CALENDAR ITEM

GENERAL PERMIT -PUBLIC AGENCY USE

LAND USE: Installation and maintenance of Goleta Beach  
Slough Revetment.

NEGATIVE DECLARATION: 86-ND-14 REVISED FINAL

Figure 2.  
Conceptual Project Plans  
Goleta Beach Park Revetment  
86-ND-14

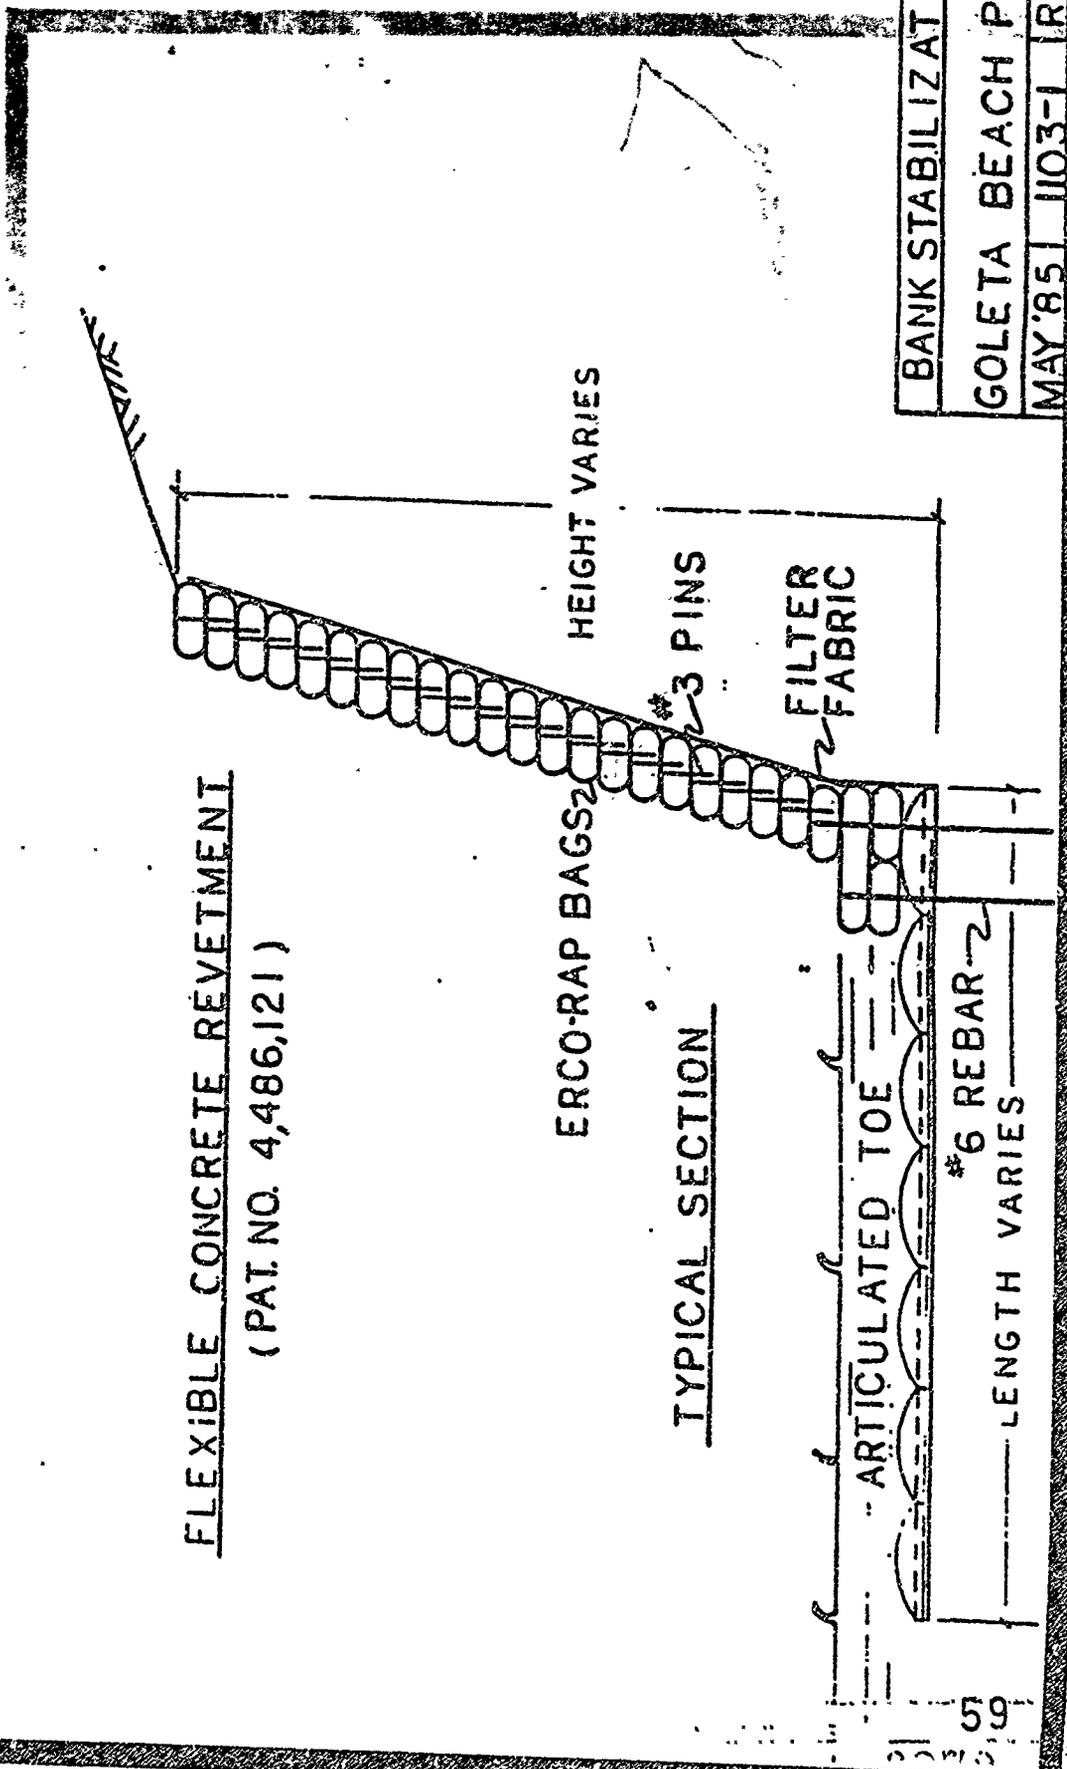
Flooding: The project site is within an area subject to flooding from the combined flows of the five creeks which drain into Goleta Slough. If the design of the revetment were to reduce the cross section of the channel, flooding hazards could increase for the area immediately upstream. To avoid significant impacts, the applicant would be required to submit engineered drawings of the proposed revetment along with the application for a Coastal Development Permit. Upon review of the engineered plans, any measures found necessary to avoid potentially significant flooding hazards shall be incorporated into the project prior to issuance of a Coastal Development Permit.

To further reduce impacts to invertebrates, fish, and birds, it is recommended that the revetment be moved to the south so that no filling of the existing tidal estuary would be required. Construction materials and equipment would be prohibited within the tidal channel or intertidal areas.

It should be noted that although various revetment designs have been considered, selection of a design has not been made due to the fact that the proposed funding is a potential State grant award, which has not been made. Until a cost amount is definitely known, the Park Department cannot commit to a design or amount of work to be undertaken.
